RSK ref: 890365-R1(0)
LPA Application ref: APP/19/01101
Environment Agency ref: HA/2019/121846/01-L01

03rd March 2020

Re: Land east of College Road, Campdown, Purbrook, Waterlooville
Response to offsite Watercourse Connectivity Enquiries

ANNOTATED
WATERCOURSE CONNECTIVITY
DRAWING

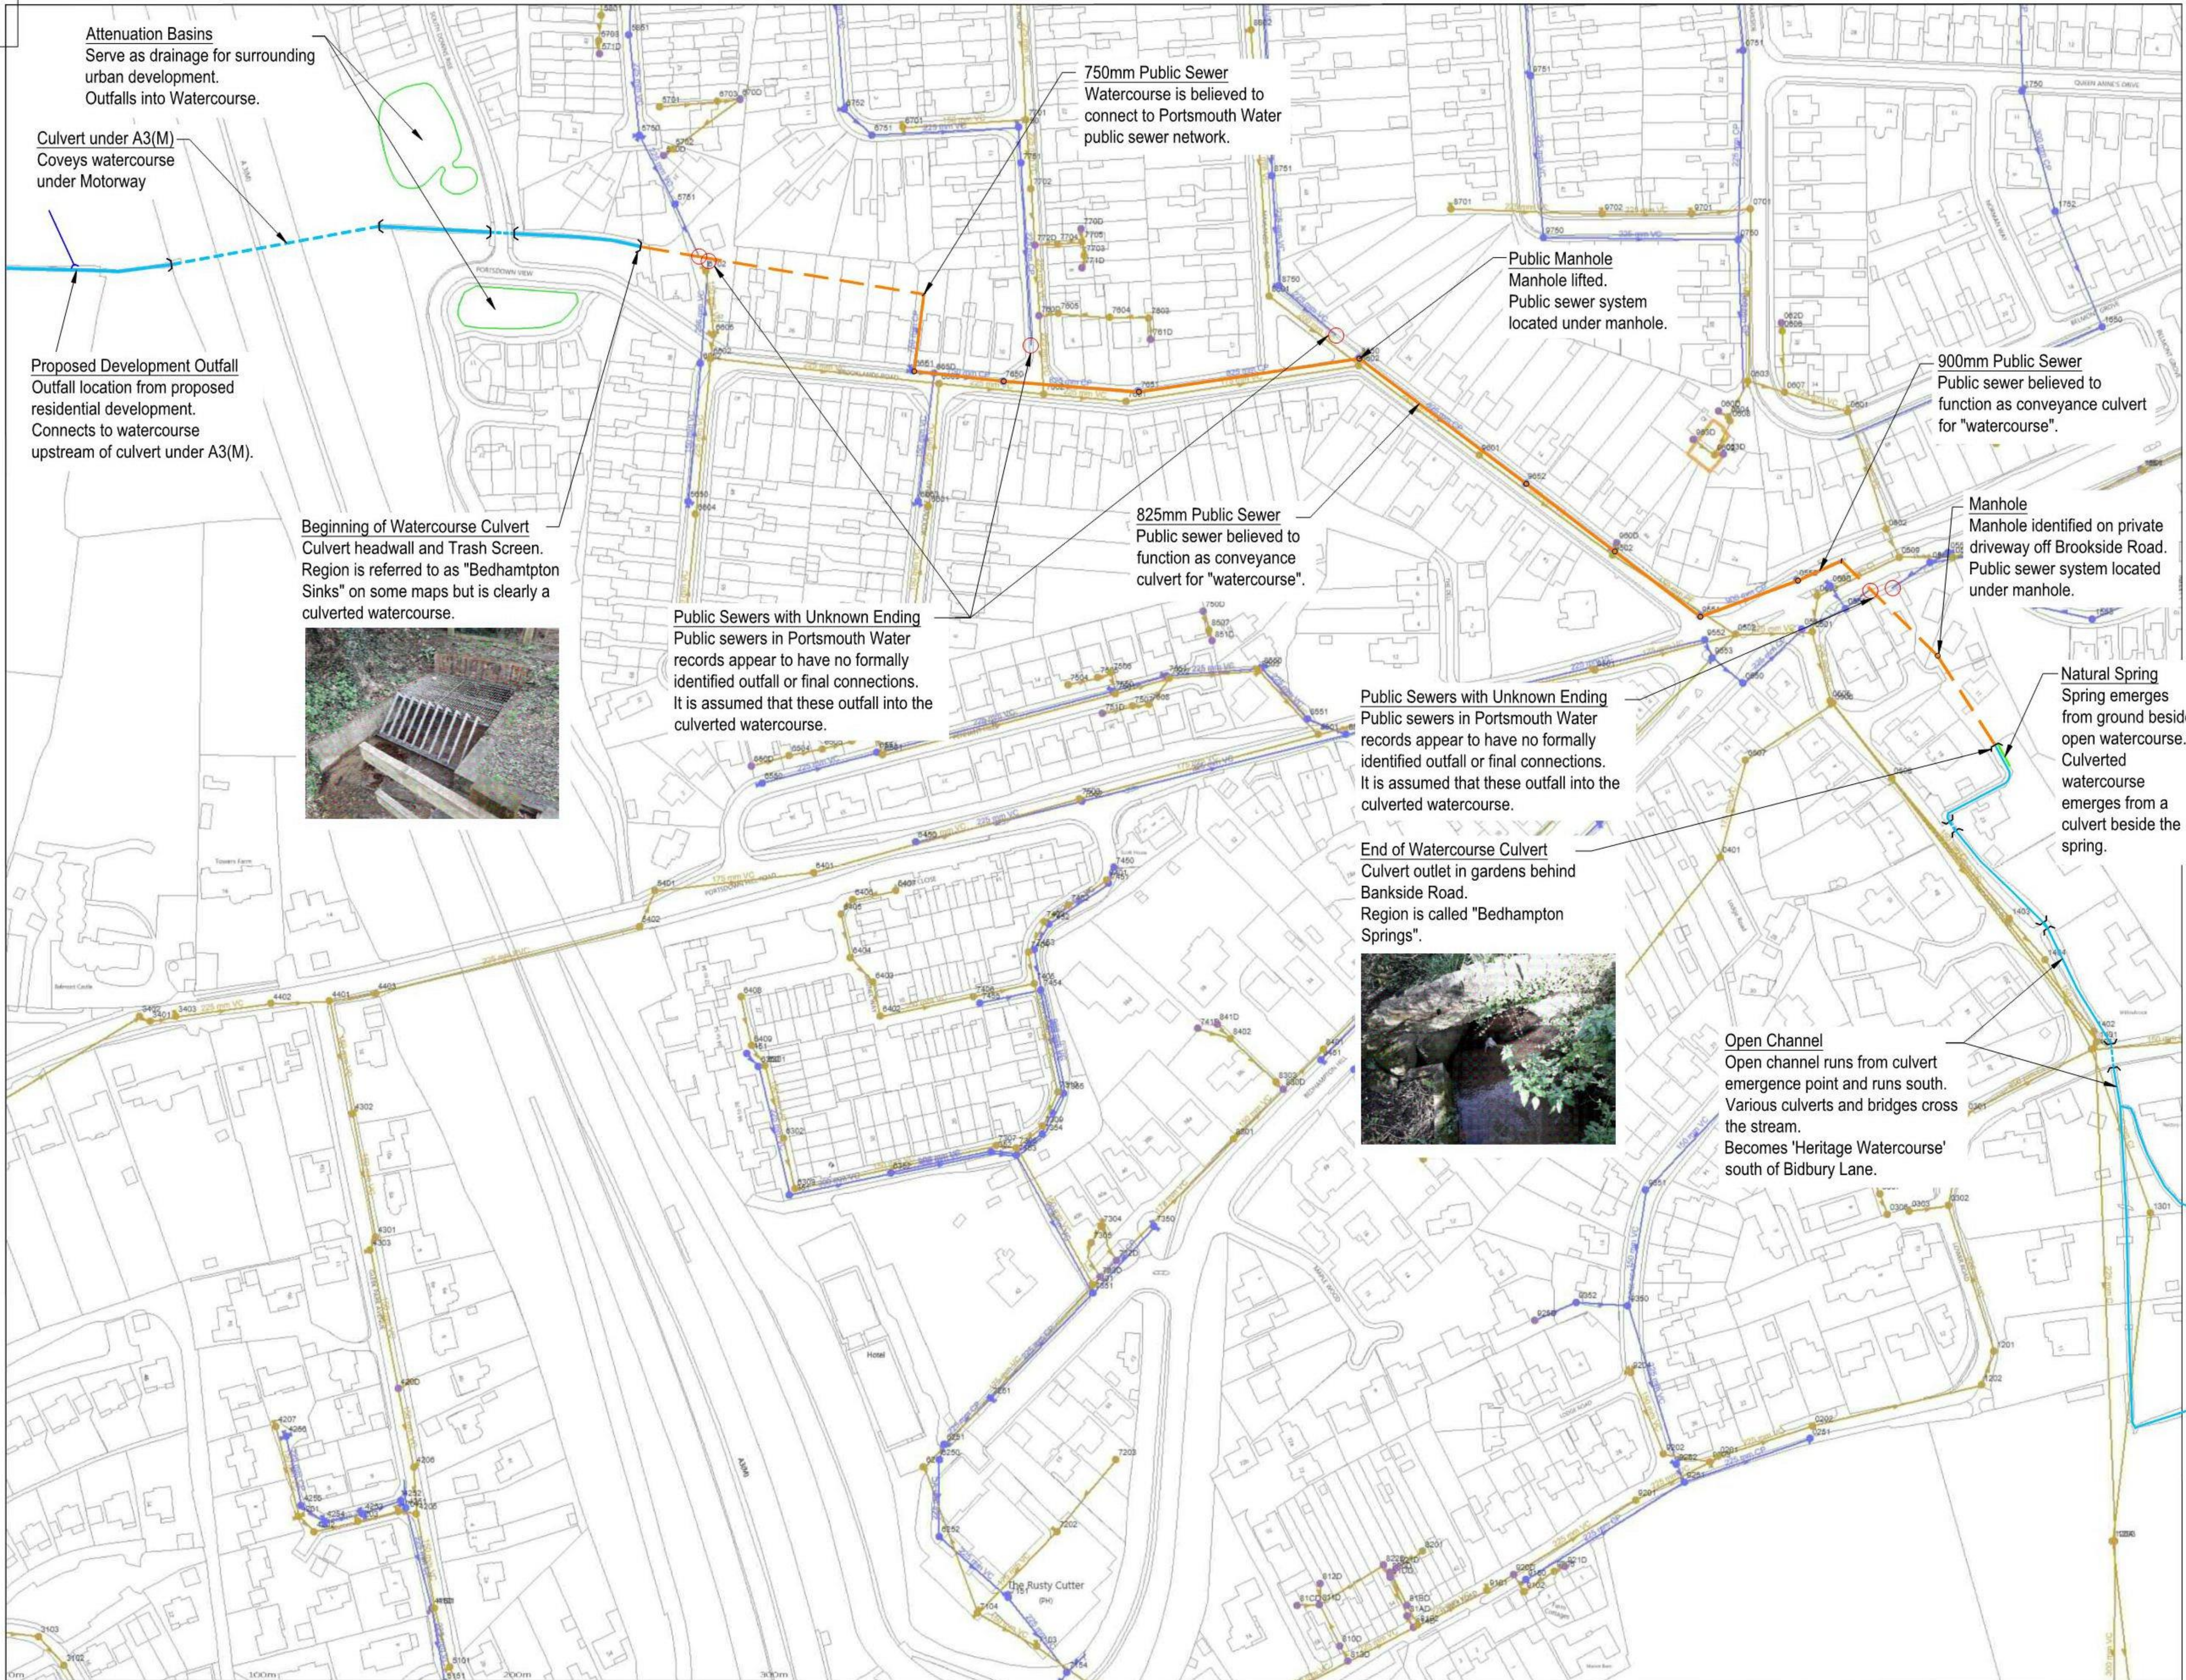
The drainage plan shows the discharge going to a stream, which has been mapped as going to a stream sink within the Source protection zone 1.

We note that the surface water drainage discharges to a small stream to the south that is shown as going to a stream sink on OS mapping. At present, there has been no investigation into this mapped stream sink, present with the application.

Groundwater in the chalk aquifer beneath the site, is within a Source Protection Zone 1, for protection of strategically important water supply sources. It is essential that this supply is protected. Stream sink can represent rapid direct pathways to groundwater.

It is essential that this apparent stream sink is thoroughly investigated to determine if there is any connection to groundwater. Without this being undertaken we cannot assess the likely risks of the development to the underlying SPZ1 and associated strategically important public water supply.

Our investigations have concluded that the unnamed watercourse does not in fact 'sink' as shown on OS mapping, but rather runs into a surface watercourse culvert that receives flow from several surface water sewers in the area, before outfalling into the downstream open channel in the private gardens adjacent to Brookside Road, approximately 600m downstream.

All of the findings described below are illustrated on an annotated drawing included as **Appendix E**.

- The floatation test proved connectivity between the culvert inlet and outlet with a travel time of approximately 17/18 minutes to cover an approximate distance of 600m.

- The culvert inlet structure located adjacent to Portsdown View had a concrete apron leading into the culvert and no signs of seepage to groundwater or springs were observed in the open channel area between the site itself and culvert inlet structure.

- Surface water outfalls from the attenuation basins constructed to drain the recent development immediately to the east of the A3(M) were observed as outfalling into the watercourse channel upstream of the culvert inlet.

- In areas around Brooklands Road and Penhurst Road, several existing public sewers appear to converge on the areas where the culverted watercourse most likely lies. No expressly identified "watercourse conveyance" culvert is identified in these records, however, most of the identified sewers simply end in these areas, implying they are connected to the culvert as their final outfall point.

- 100m downstream from the culvert inlet structure, the published sewer records show a 750mm surface water sewer starting and running between the properties to the north of Brooklands Road before running parallel with Brooklands Road, Maylands Road and Bedhampton Road. The final 85m of this culvert is not shown on the sewer record mapping but is believed to turn south and run beneath gardens to the east of Brookside Road before outfalling into the open channel shown in Figure 3 and Figure 4.

- The route of this culverted watercourse/surface water sewer is confirmed in **Appendix E**.
